**KINGS LYNN
HARDINGS WAY ACCESSES**

STAGE 2 SAFETY AUDIT

**REPORT REF: U23679/001
July 2017**

Highway Group
Norfolk County Council

6.0 Problem Location Plan

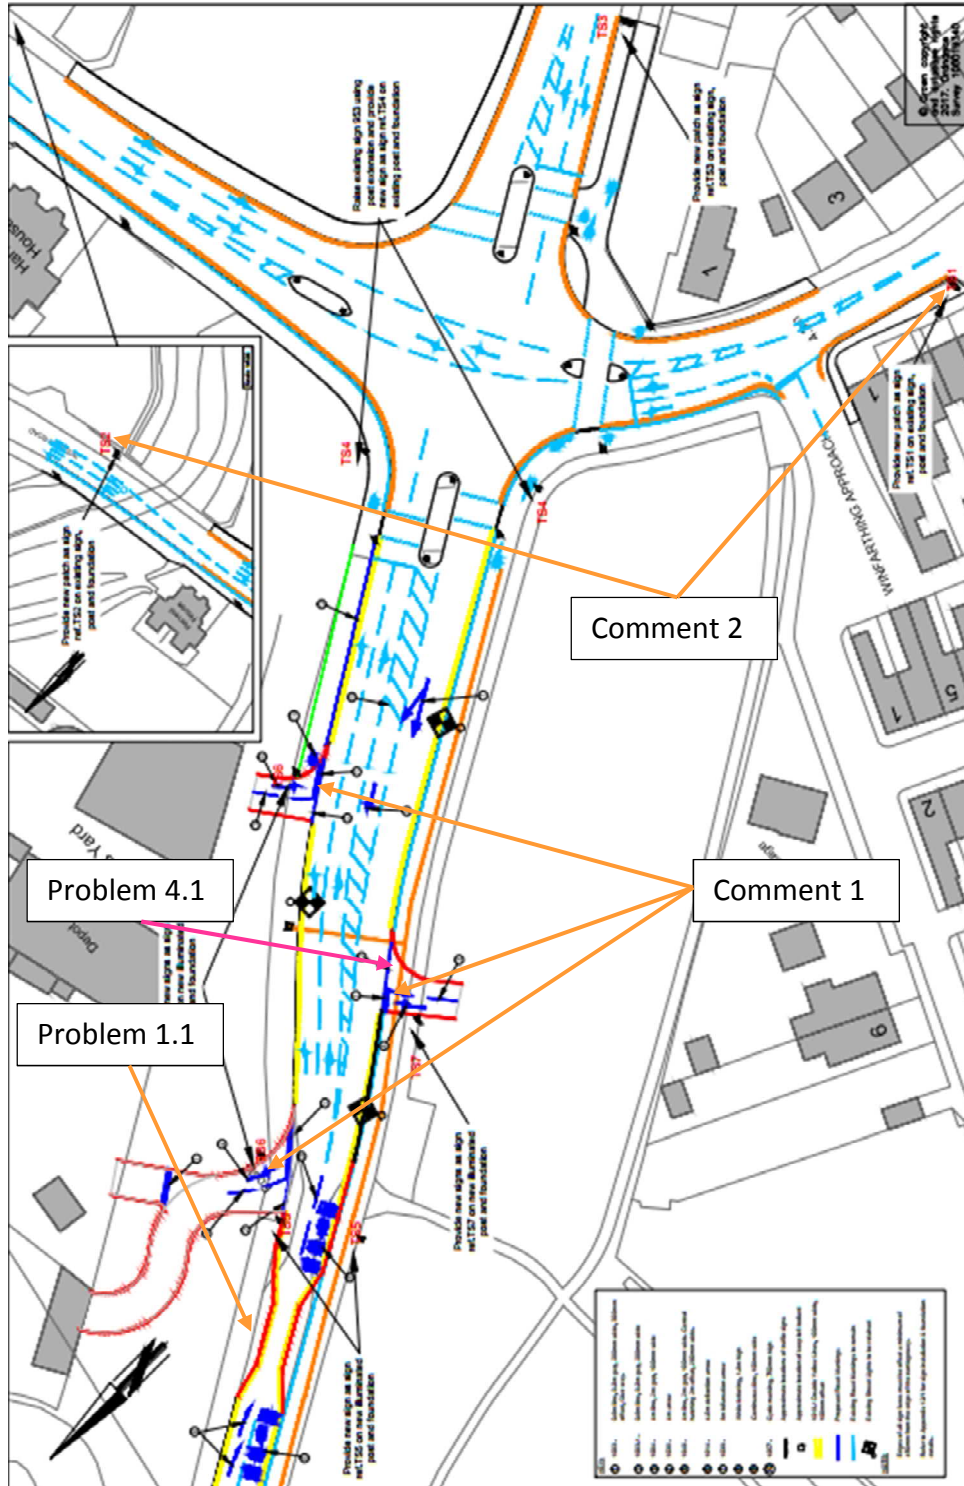
The scheme comprises three accesses on Hardings Way, the west of which cuts through an existing shared use facility. This disadvantages vulnerable users.

Recommendation – given the low levels of anticipated usage here, the shared use facility should be given priority, continuing unbroken across the access, with the associated give way lines for the vehicular access set back.

Agreed - The associated give way lines on the western proposed access will be moved further behind the shared-use facility allowing the facility to continue unbroken across the access. Similar facility will be provided on remaining two accesses on eastern side as well given proposed shared use facility on that side.

SURVEYED BY	INITIALS	DATE	DRAWING No.
OS	OS	2017	PK6062-HP1-002C
DESIGNED BY	MJL	07/17	PROJECT TITLE
DRAWN BY	AM	07/17	Kings Lynn, Hardings Way Accesses Improvement Scheme
CHECKED BY	DW	06/16	SCALE 1:500 @ A1 FILE No. PK6062

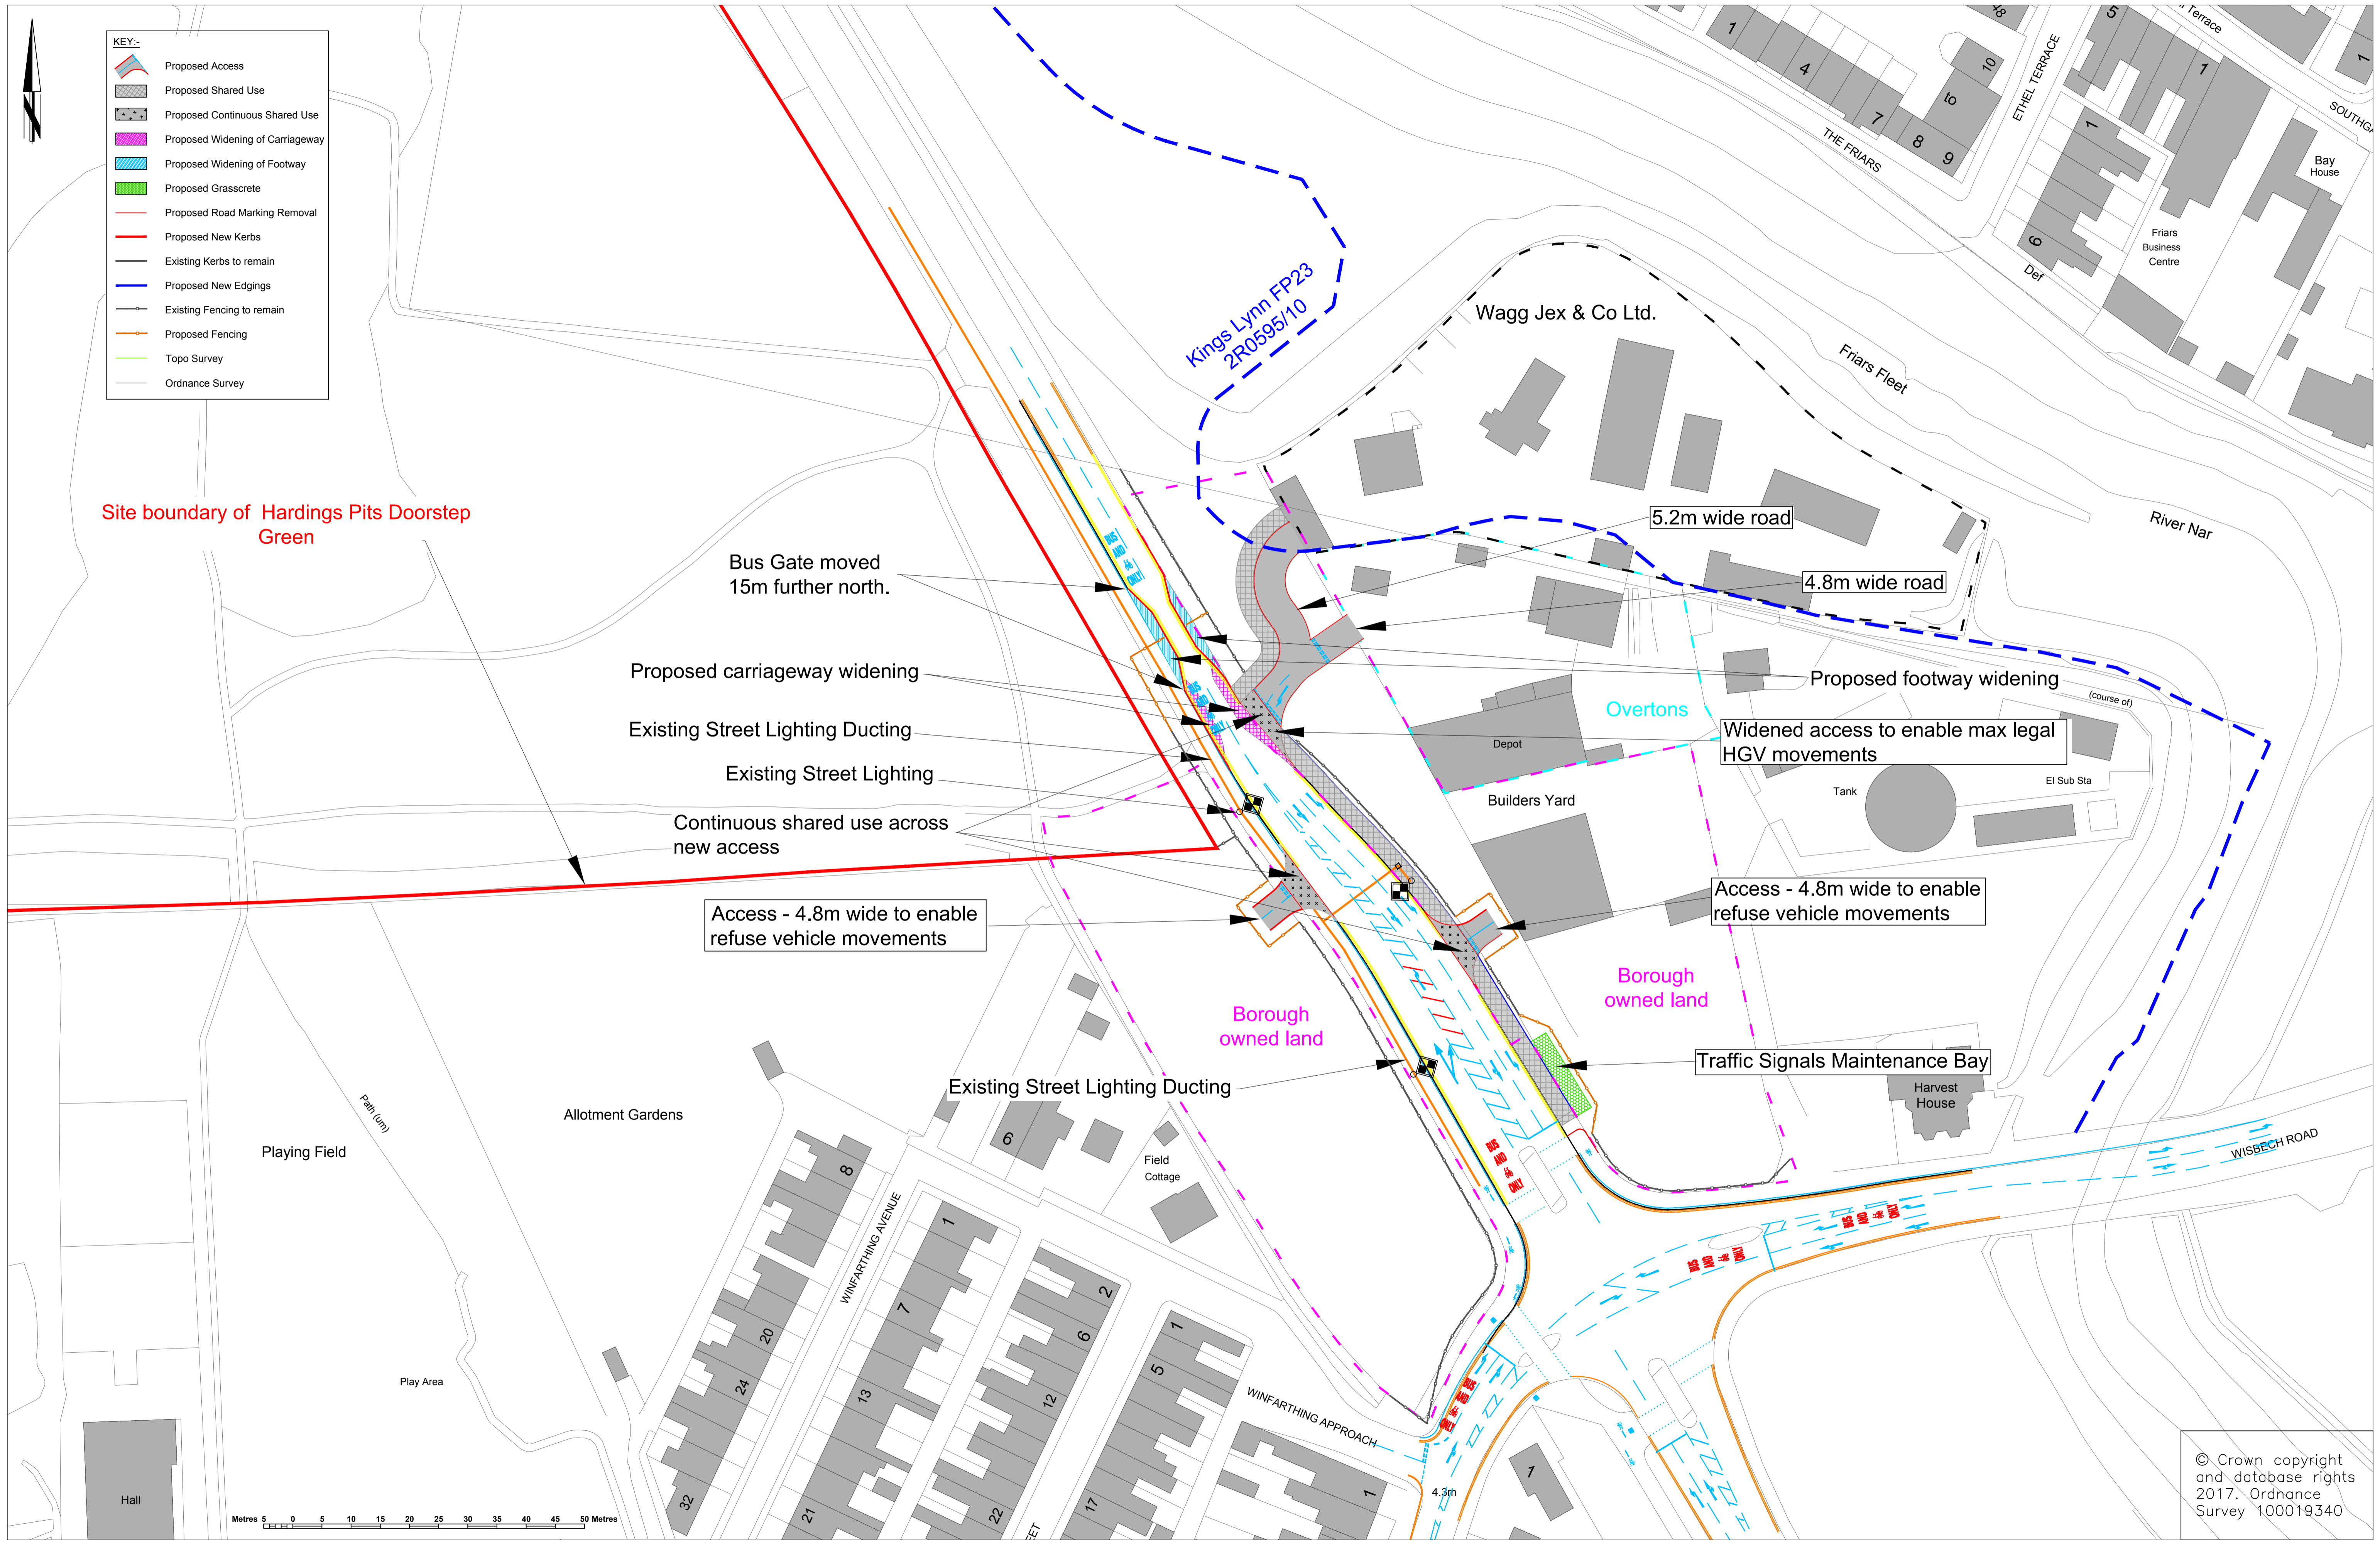
The bus gate is currently bounded by bollards on the west side, and a fence on the east. The scheme proposes to relocate the bollards but not the fence. Vehicles may therefore attempt to pass by the east side of the bus gate, with an increased risk of conflict, particularly with vulnerable users.

Recommendation – provide measures to stop vehicles passing by the east side of the bus gate.

C.1 The scheme proposes right and left turn bans to deter vehicles from heading in the direction of the bus gate. A side effect of these bans would be to constrain the order in which a driver may use multiple accesses. The bus gate physically stops illegal usage and the scheme would not suffer if these bans, and associated signing, were omitted.

Agree - The fence will be provided on the east side of the relocated bus-gate to stop vehicles passing by.

Noted - The right and left bans to deter vehicles from heading in the direction of the bus gate will be removed and adjacent corner radii increased.
